NISTUNE TECHNICAL BULLETIN #002

TITLE : Correction of ECU Air Flow Meter modifications

Models covered: HR31, RB20DET, CR31 RB30E, VLT RB30ET, Z31 VG30E/ET (1986-1987)

Date: 26 September 2009. Revised 26 March 2012

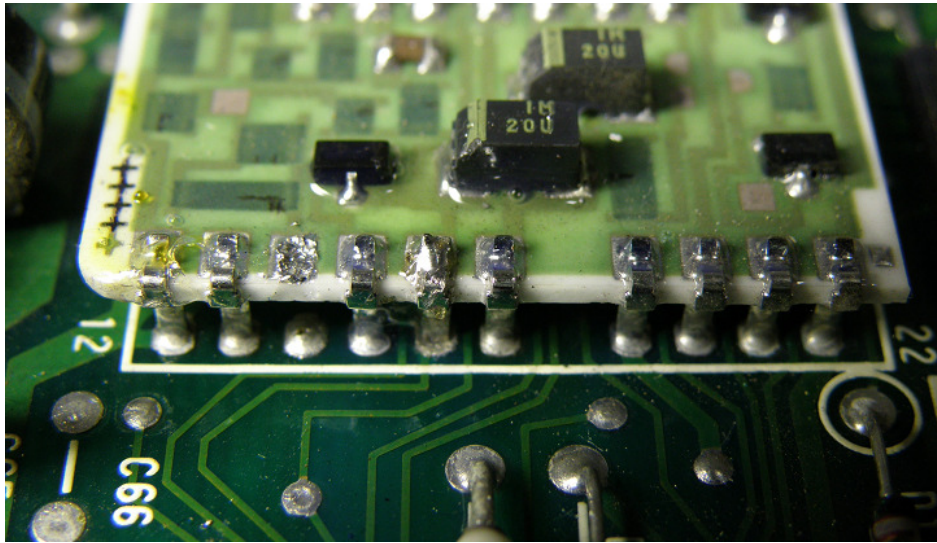
Following this modification it has been noticed during field testing that logs have indicated that 0 and 5 volt spikes in the AFM signal received by the HD46510 chip have been received and processed as can be seen below:

The removal of the opamp from the circuit has affected filtering of the ECU and occasional spikes in the fuel injection could be potentially noticed. In the log above TP was not affected, so the map points accessed were not changed.

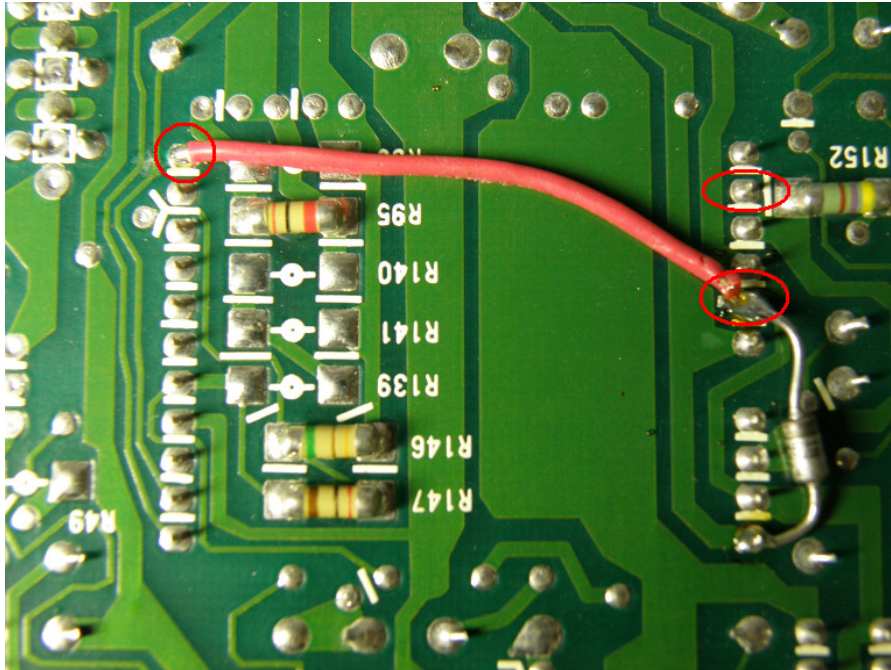
The following steps detail the reversal of the previous modification required and the steps to perform the updated modification.

1. On the reverse side of the ECU desolder and remove the installed wire jumper and zener diode
2. Desolder the holes which are highlighted by the red circles in the diagram

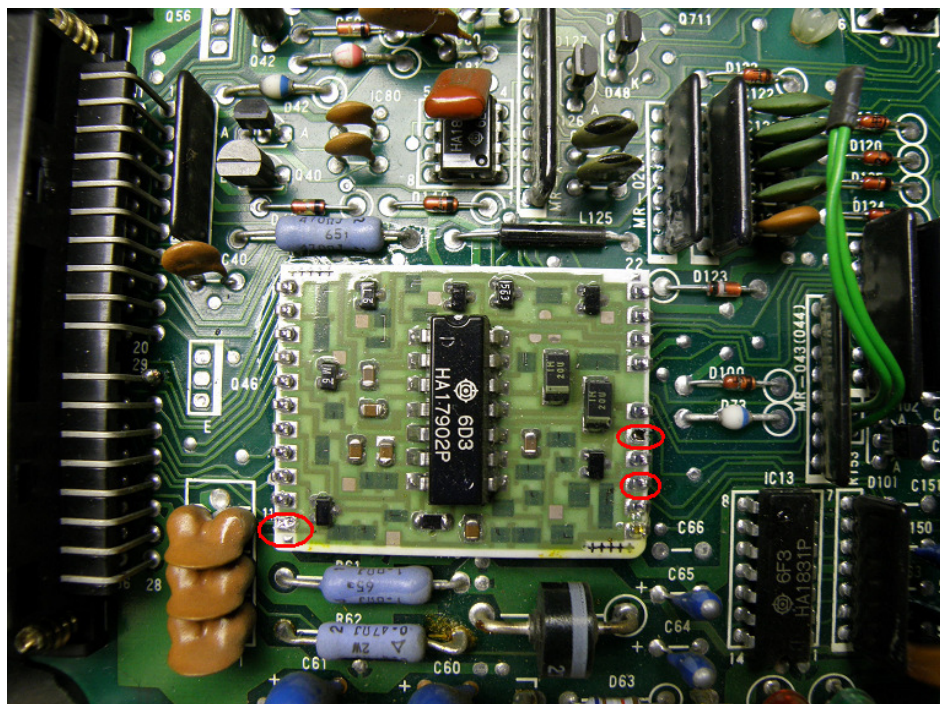
3. Remove Pin 14 (lower RHS) from the board and move to previously removed Pin 16 (upper RHS) and solder in. Reinstall Pin 11 (lower LHS) to the board using jumper wire or similar. Remove the previous diode installed

Note: Silkscreen on the circuit board shows pins 1 ..11 LHS and 12 .. 22 RHS

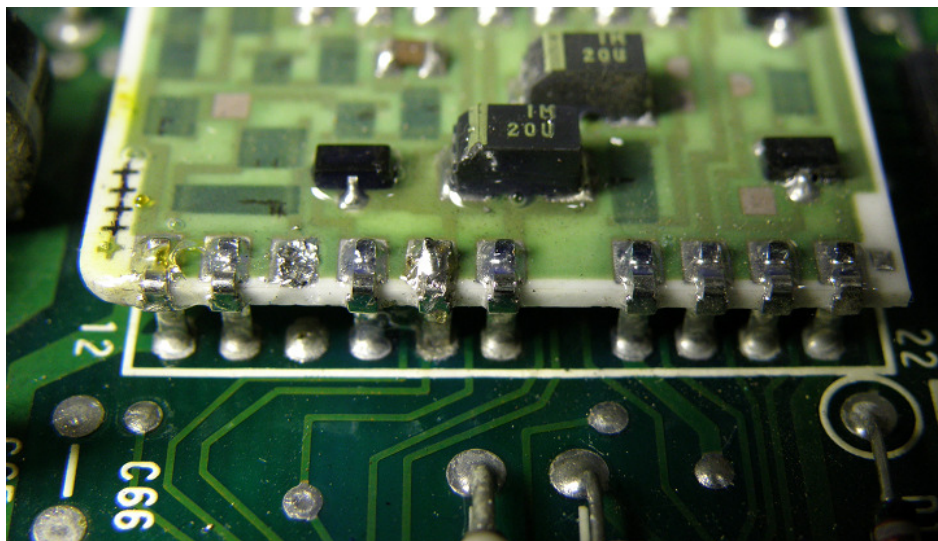
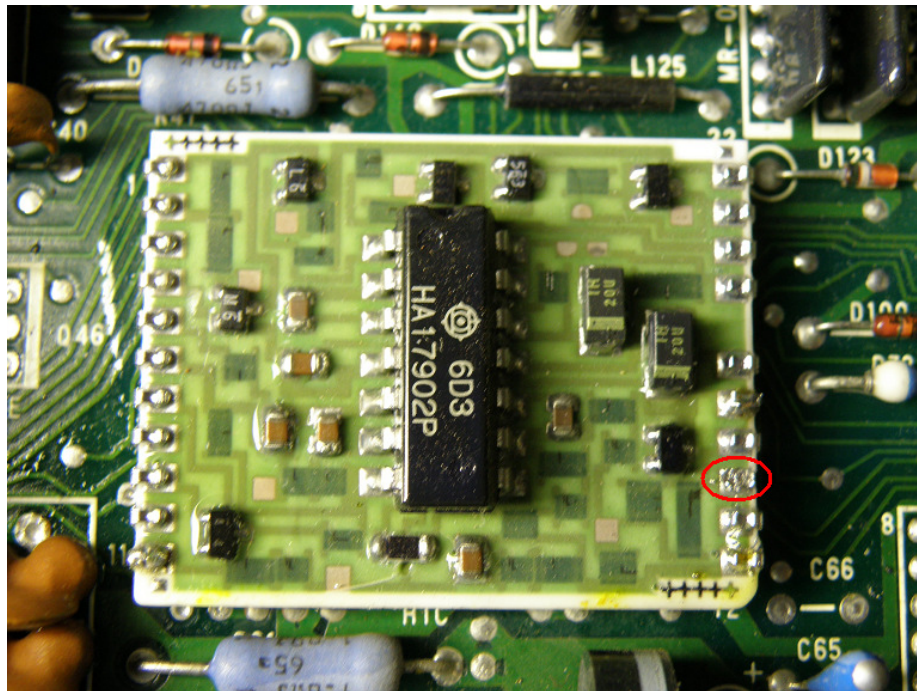
4. Now the circuit board should look like the picture below. Both pin 11 and pin 16 have been resoldered and pin 14 (highlighted) is now removed

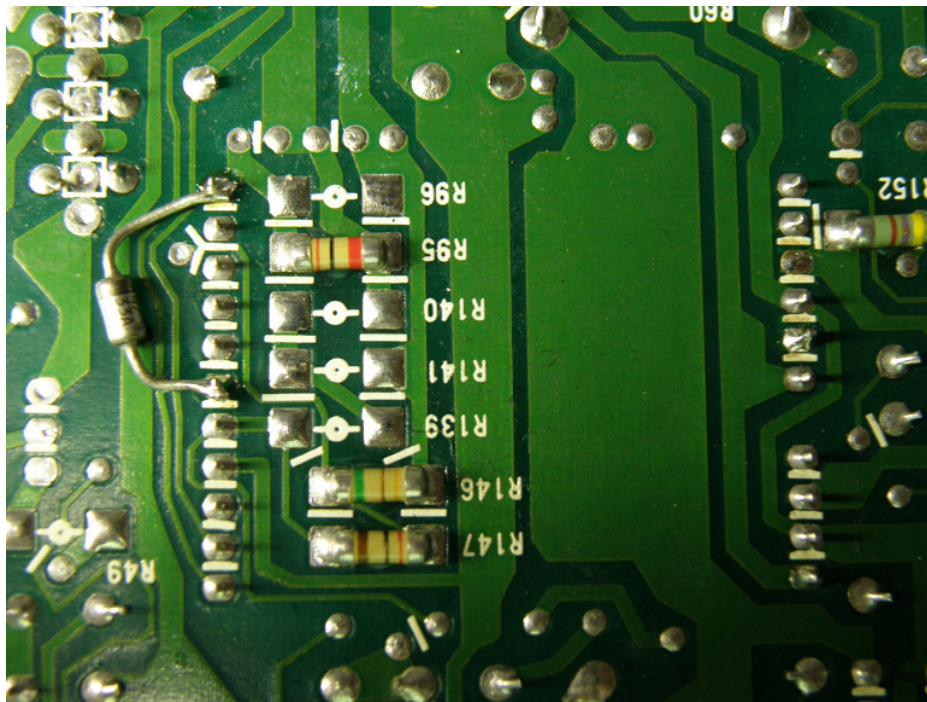
5. Retaining the zener diode is still recommended, as the opamp may not protect against over voltage from the AFM if it occurs. It will need to be moved to the input side of the ECU

Solder the banded end of the zener diode to pin 11, and the other end to pin 6 as pictured below.
